LOCATION Jessop's Creek Culvert

**FINAL FOUNDATION INVESTIGATION AND DESIGN REPORT FOR
PROPOSED JESSOP'S CREEK CULVERT
HIGHWAY 11 FOUR LANING
6.7 km NORTH OF HWY 60 NORTHERLY 13 km
W.P. 462-93-00,
DISTRICT 52, HUNTSVILLE**

**Response to MTO Comments of March 8, 1999
Final Foundation Design Report for
Proposed Jessop's Creek Culvert
Highway 11 Four Laning
6.7 km North of Hwy 60 Northerly 13 km
W.P. 462-93-00
District 52, Huntsville**

19-1351-7h-01

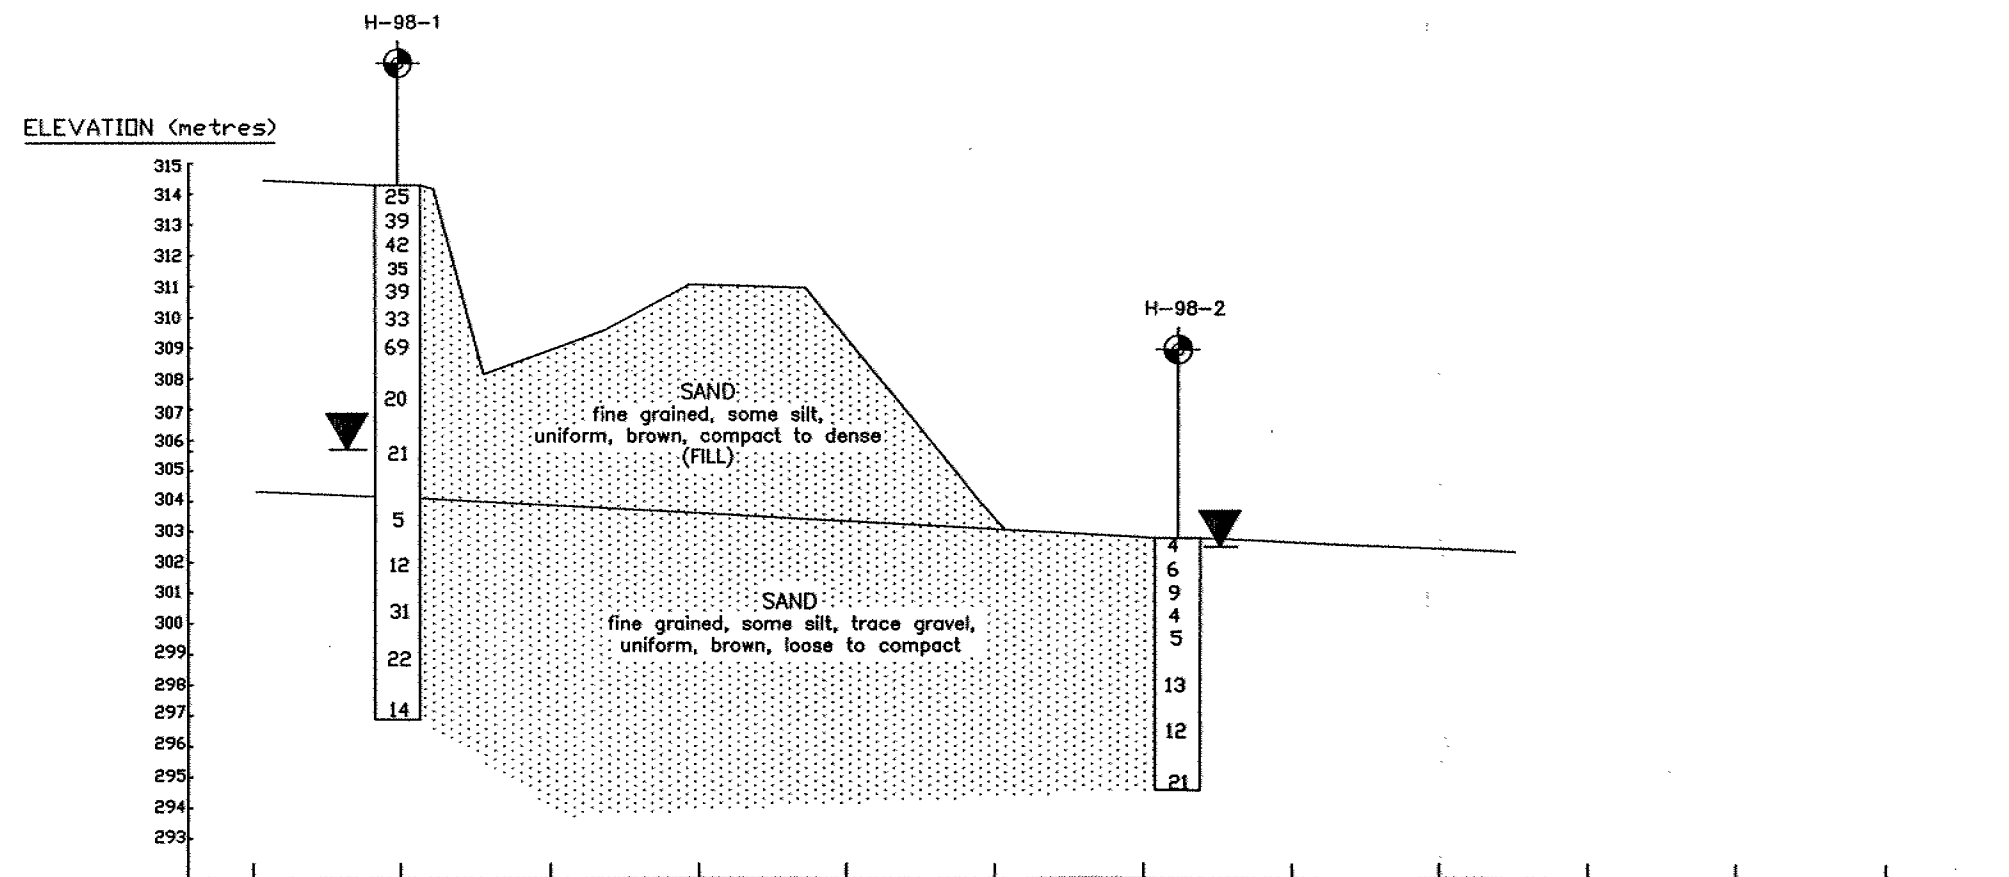
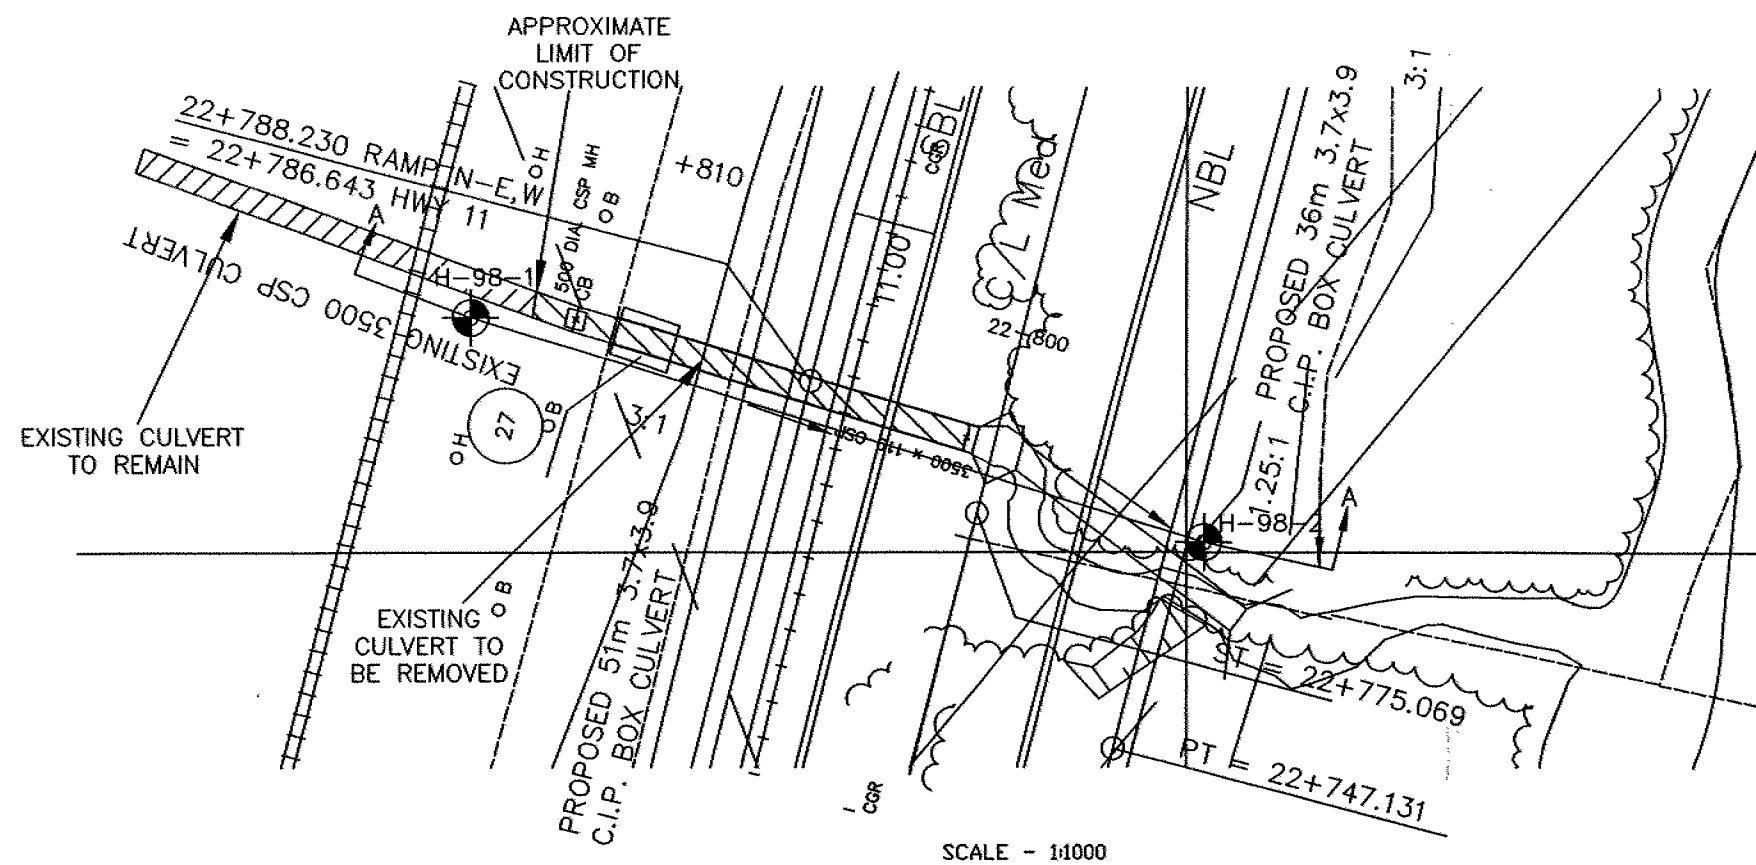
- 1) The Site # should be indicated on the title page and on the Foundation Drawing.
- 2) The Foundation Drawing does not meet our expectations. Normally north would be to the top of the page although I understand that there may be a reason for orienting this way. The section line should be shown on the plan. The existing culvert location on the plan should be clarified (bolded). ✓

The culvert invert elevation should be illustrated on the Borehole and Soil Stratigraphy Drawing.

2. Foundation Drawing. A profile line has been added. The orientation of the drawing is correct. The north arrow was incorrect and has been corrected. The location of the existing culvert has been clarified.
